Material Change for Extension Interface Covers for GT27 and GT25 Models for Overseas

GOT2000 Series

GOT-A-0223-A

2 Details of the change

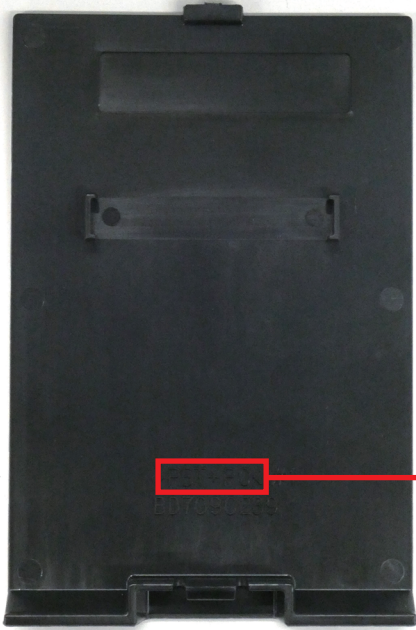
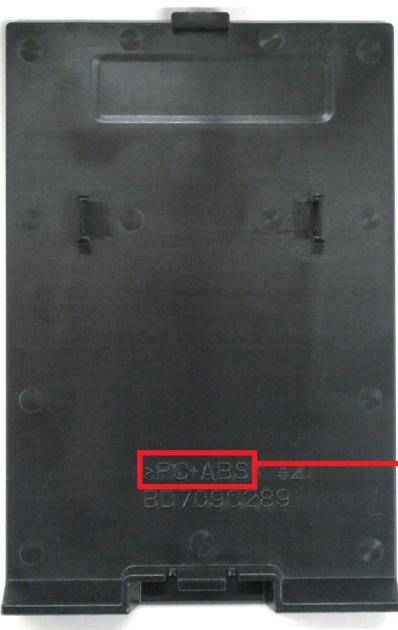
We will change the material of the extension interface covers on the GOT rear face.

Along with the change, the description of the material will be changed.

The color may appear different depending on the viewing angle and the reflection of light.

Item	Before	After
Material	PBT+PC	PC+ABS
Material indication on the back side of the extension interface cover
